9 Cathedral Square proposed canopy – submissions and project team responses

Attachment 1 - System of cloisters or arcades proposed in Cathedral Square by the Christchurch Civic Trust

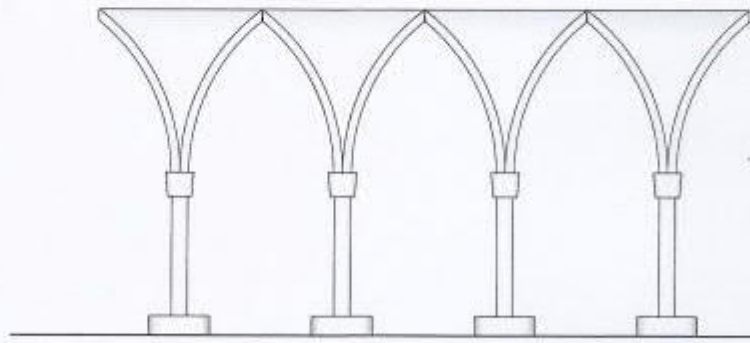
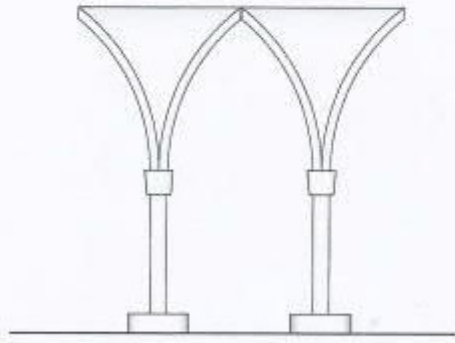
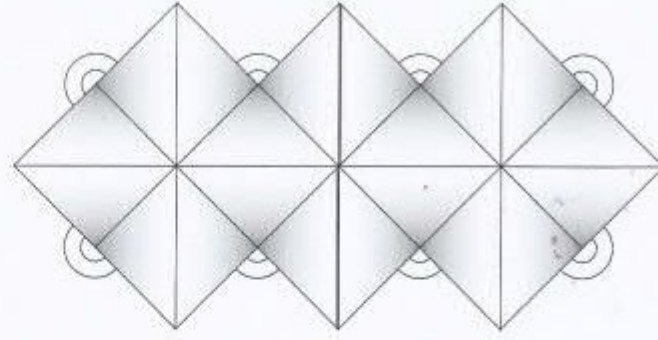
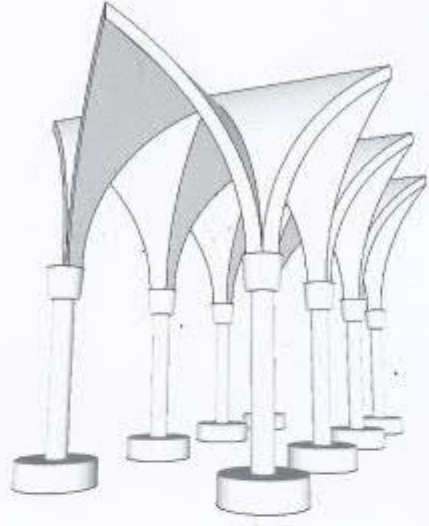
<p>lime tree specimens, particularly in autumn and winter, is likely to create an overstated, perhaps even conflicting visual dynamic which has the potential to detract from the trees themselves and from the visual experience intended by the applicant and architects. We believe that this matter needs more careful consideration by all concerned.</p> <p>Further, as raised in the public consultation document, the presence of the canopy and supports, in conjunction with the glazed north façade of the building, could potentially blur the claimed re-definition of the Maltese Cross / cruciform which Ms May asserts had been lost with the previous building on this site, the ANZ Bank, following the demolition of the United Services Hotel building.</p> <p>On several occasions since 2014 the Christchurch Civic Trust has publicly suggested that a system of cloisters or arcades could be placed by the Christchurch City Council on council-owned heritage scheduled land in Cathedral Square at a height and of a scale and in design terms which would help to unify Cathedral Square and personalise the Square experience for residents and visitors alike. (See Attachment 1 below.) What the proposed canopy might offer the Square-goer bears little resemblance to the potential experience offered by the cloisters / arcades concept, as outlined.</p> <p>We urge the Christchurch City Council to reject the application for the canopy at its present dimensions and that the applicant be requested to re-design the required provision of shelter along the north face of the new building.</p> <p>Thank you.</p> <p>Additional comments</p> <ol style="list-style-type: none"> <li>1. Error: it has been brought to our attention that the three lime trees referred to in our submission, although situated in the scheduled Highly Significant Cathedral Square space, are not themselves specifically designated as scheduled trees under the City Plan. However, there is every reason to think that they could be at some point. The application of a designation would depend on the trees being in good biological and aesthetic condition, which we maintain could be severely jeopardised if the canopy were built as planned.</li> <li>2. Error: we should have referred to the building with veranda formerly on the site as the United Service Hotel.</li> <li>3. Clarification: our reference to the form of Cathedral Square as 'Maltese Cross / cruciform' in relation to a comment by Jenny May acknowledged her description (Maltese Cross), but indicated that it is also described by some as a cruciform shape. There is considerable variance in choice of descriptor; we believe that the term 'cruciform' better represents the typology of the space.</li> <li>4. Additional observation: we question whether any consideration had been given to the problem of birds, mainly seagulls, using the upper branches of the supports as very convenient perches, nicely placed above table-based food sources. Equally, the well-known propensity for dogs to be attracted to pillars and posts could provide a problem for the maintenance of the lower support structures.</li> </ol>
